Re: Shop Remodel @ 2136 Sutterville Road

You contacted me regarding a roof framing change at your building remodel on 2136 Sutterville Road in Sacramento, California. Specifically, you wanted to reconfigure the cricket roof behind the front parapet corners to incorporate a valley in lieu of the rake wall shown on the plans.

DETAIL A-1 NOT TO SCALE

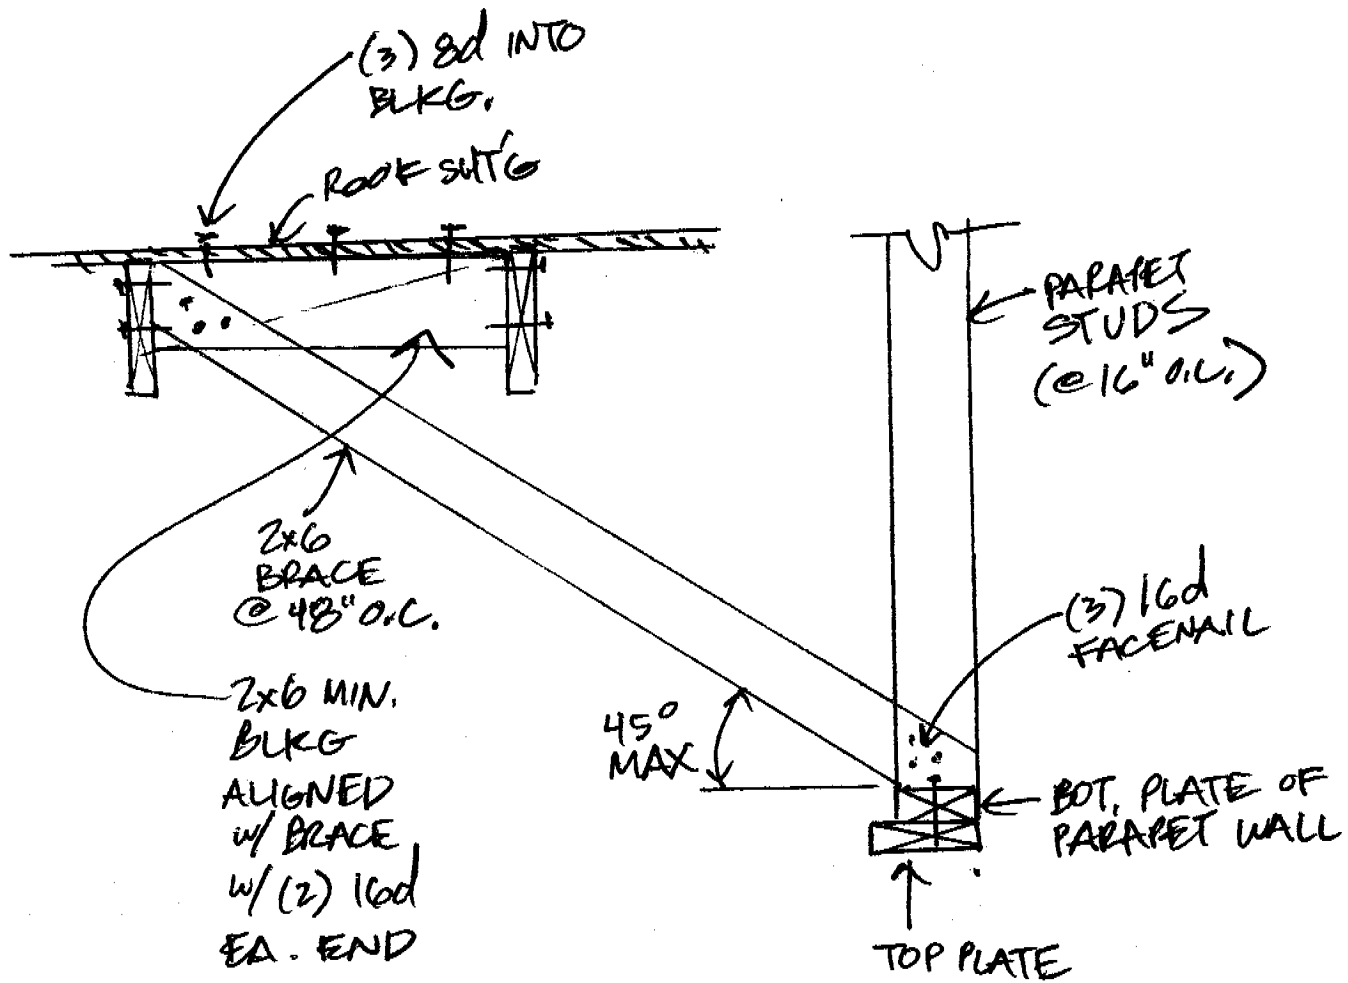
I visited the site on April 1, 2001 to observe the new roof configuration. I determined that the front parapet wall was adequately braced in the as built condition, provided the corrections below. However, the parapet return walls over the sides of the building were not adequately braced in the as-built condition, and would require additional reinforcement. After reviewing the wind loads and existing framing, I determined that the parapet return walls could be adequately braced by using horizontal knee braces on each corner of the parapet wall at the top plates. We have provided a detail sketch of the bracing assembly to use. Please refer to the attached sketch A-1.

Sketches A-1, A-2, and A-3 supersede the bracing concepts shown on the approved plans and shall be used as substitutes. If you should have any further questions or comments please do not hesitate to contact me.

| DETAIL A-2 | NOT TO SCALE

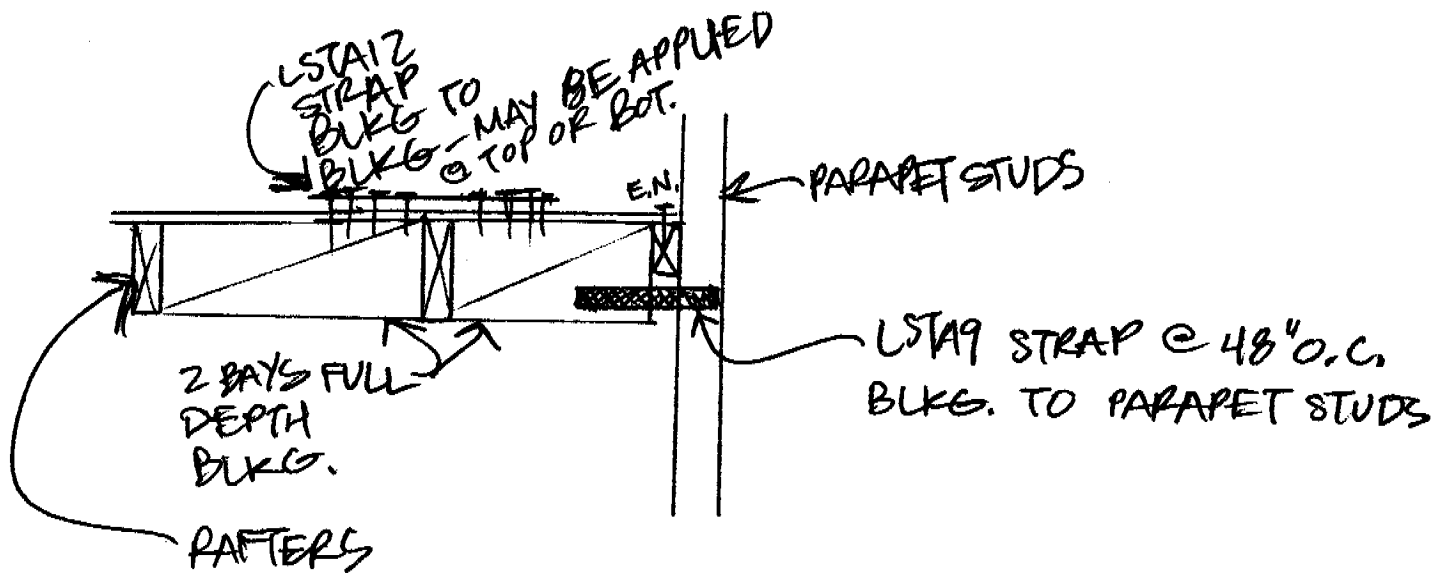
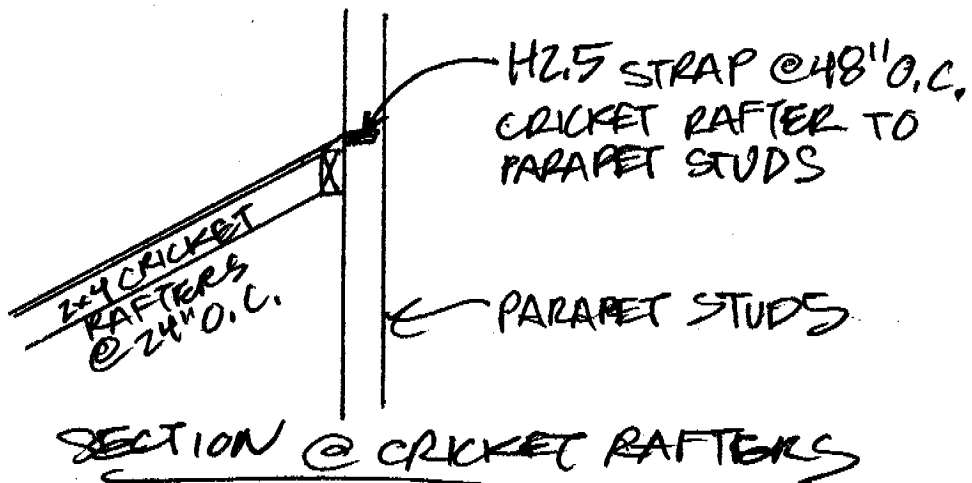
As referenced above, the front parapet wall required additional bracing. The plate below the bottom plate of the parapet wall will need to be braced per the detail sketch provided. See sketch A-2. The studs at the parapet wall will also need to be tied back to the main and cricket roof framing as shown in the attached sketch. See sketch A-2.
